## Riley Purgatory Bluff Creek Watershed District Permit Application Review

**Permit No:** 2022-068

**Project:** KIWATCHI home development– The applicant proposes the demolition of an existing single-family home and the construction of four residential single-family homes and associated stormwater infiltration basin

**Reviewer:** Katherine Tomaska, EIT, and Scott Sobiech, PE, Barr Engineering

**SWPPP PLAN**  
**C3-2**

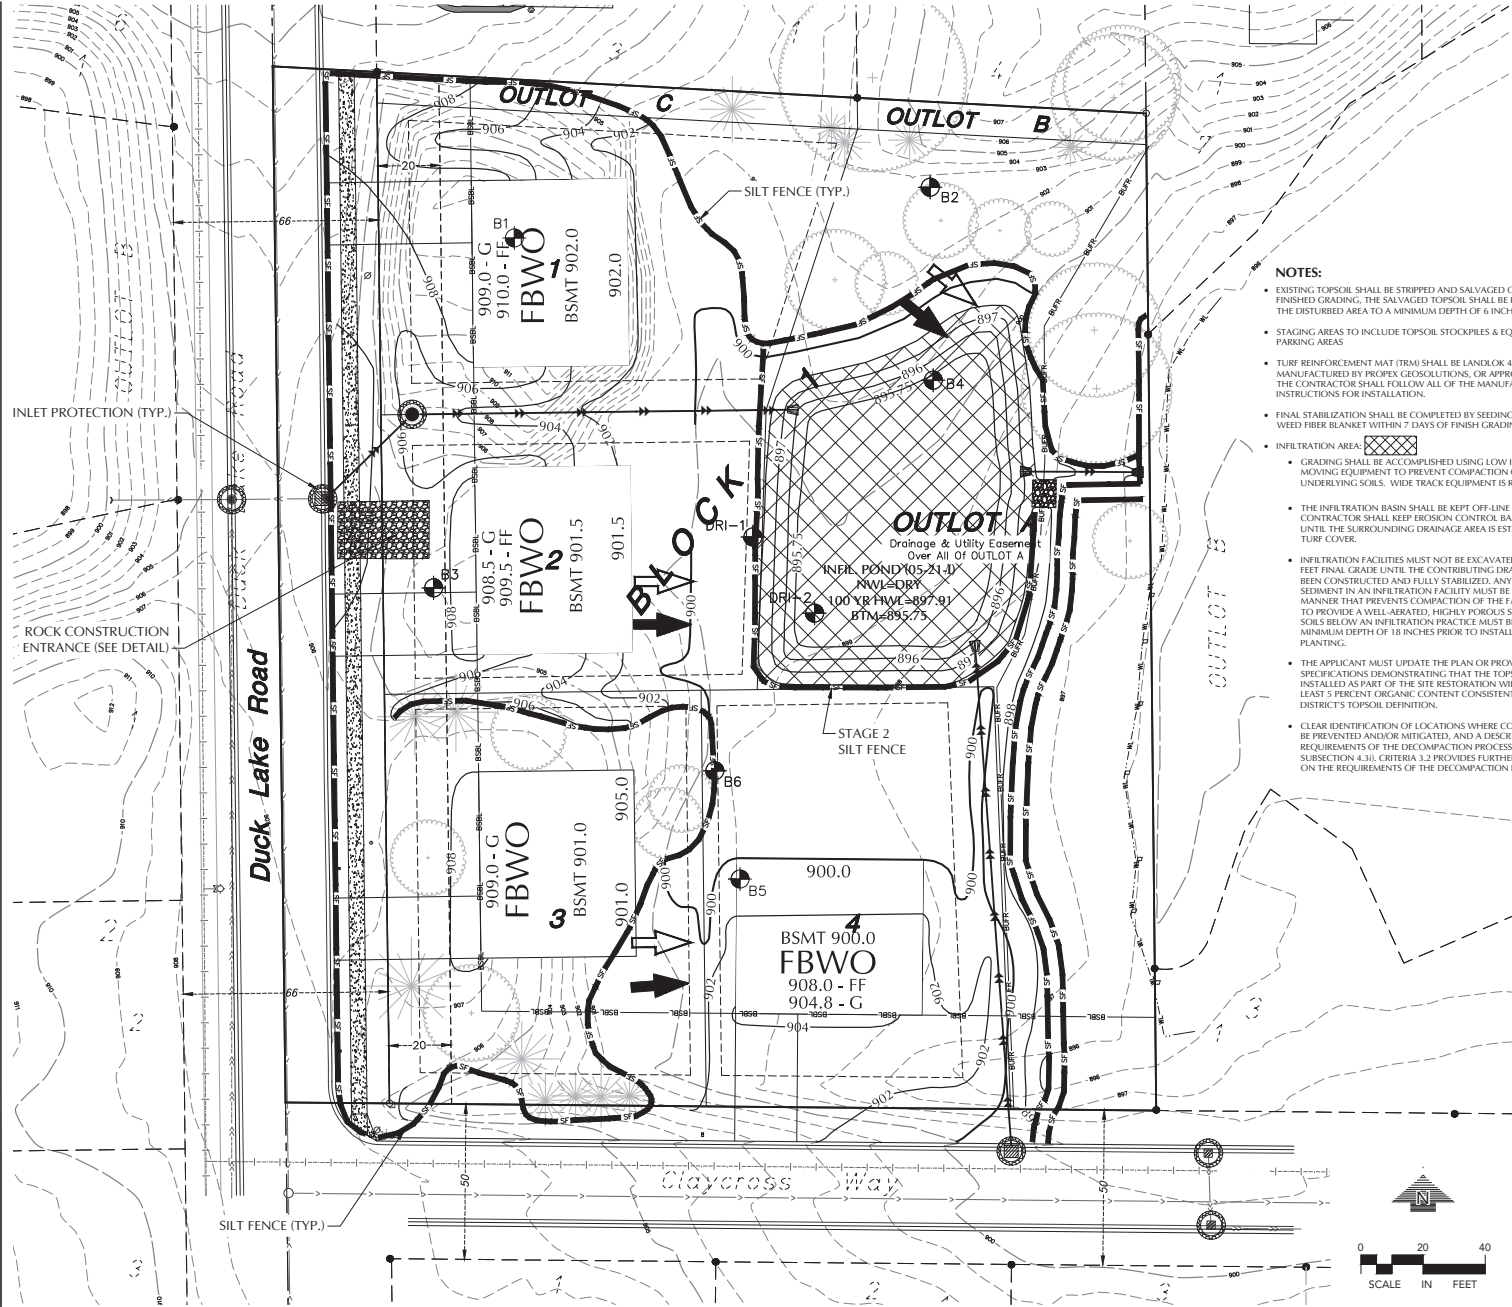
- THE APPLICANT MUST UPDATE THE PLAN OR PROVIDE THE PROJECT SPECIFICATIONS DEMONSTRATING THAT THE TOPSOIL TO BE INSTALLED AS PART OF THE SITE RESTORATION WILL CONTAIN AT LEAST 5 PERCENT ORGANIC CONTENT CONSISTENT WITH THE DISTRICT'S TOPSOIL DEFINITION.
